Z-27
(2014)

ZONING PLAN EOR:

PETITION NO: Z-27

ZONING COMMENTS:

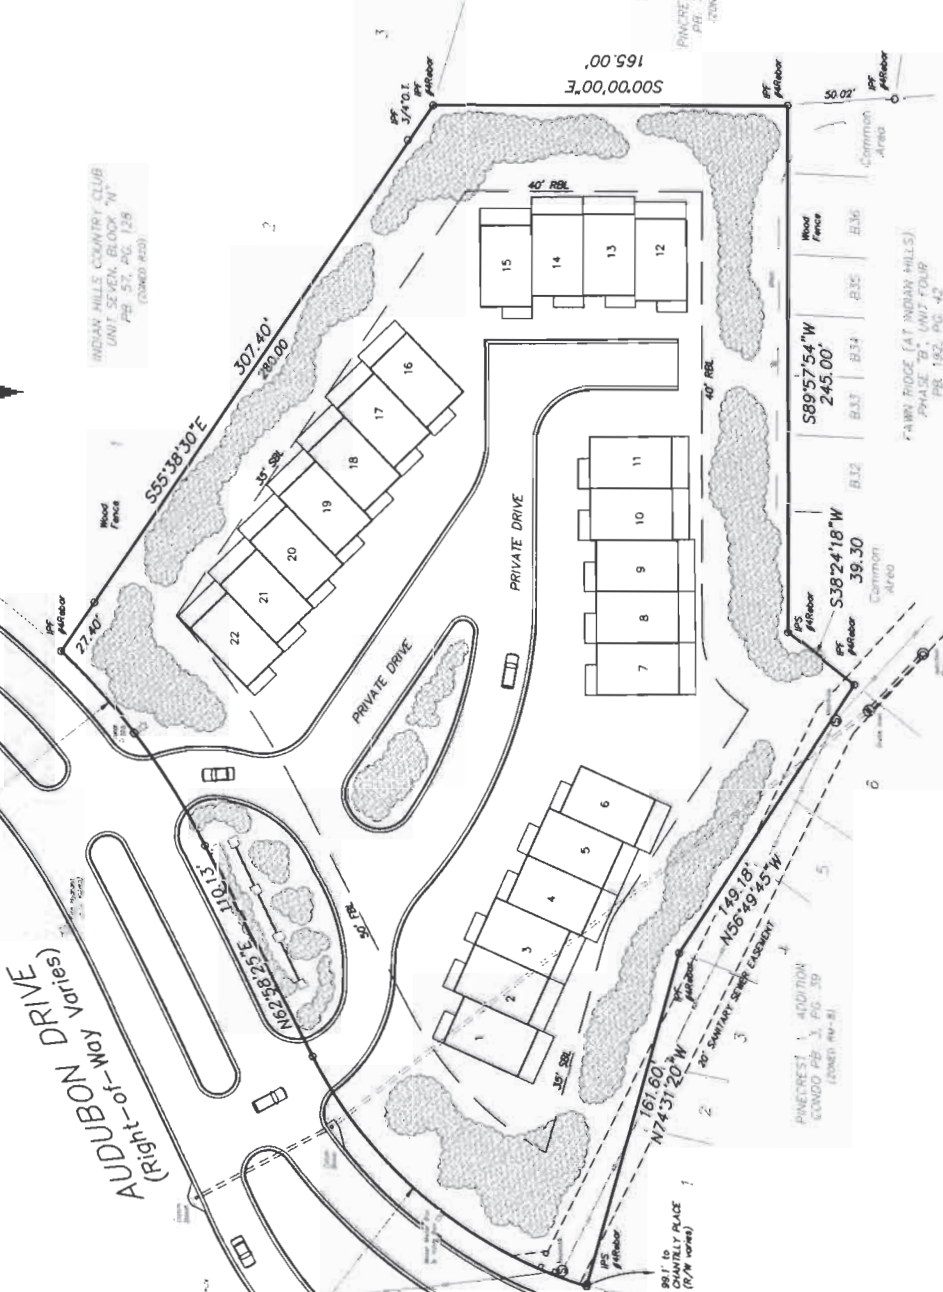
There is a required 25-foot landscape buffer required along the north property that is not shown.

- Provide comprehensive hydrology/stormwater controls to include development of out parcels.
- Submit all proposed site improvements to Plan Review.
- Any **spring activity** uncovered must be addressed by a qualified geotechnical engineer (PE).
- Structural fill _____ must be placed under the direction of a qualified registered Georgia geotechnical engineer (PE).
- Existing facility.
- Project must comply with the Water Quality requirements of the CWA-NPDES-NPS Permit and County Water Quality Ordinance.
- Water Quality/Quantity contributions of the existing lake/pond on site must be continued as baseline conditions into proposed project.
- Calculate and provide % impervious of project site.
- Revisit design; reduce pavement area to reduce runoff and pollution.

- No Stormwater controls shown _____
- Copy of survey is not current – Additional comments may be forthcoming when current site conditions are exposed.
- No site improvements showing on exhibit.

Recommend curb and gutter along both sides and sidewalk along one side of proposed development roadway.

Recommend sidewalk along the Audubon Drive frontage.

Recommend applicant verify that minimum intersection sight distance is available for ingress and egress maneuvers for the site if it is not, implement remedial measures, subject to the Department's approval, to achieve the minimum requirement of 280'.

- Maximum of 5 units per acre, which yields 14 lots;
- 25 foot landscape buffer be installed along the north property line adjacent to the R-20 zoned properties;
- Final site plan be approved by the District Commissioner;
- Fire Department comments and recommendations;
- Water and Sewer Division comments and recommendations;
- Stormwater Management Division comments and recommendations;
- Department of Transportation comments and recommendations.
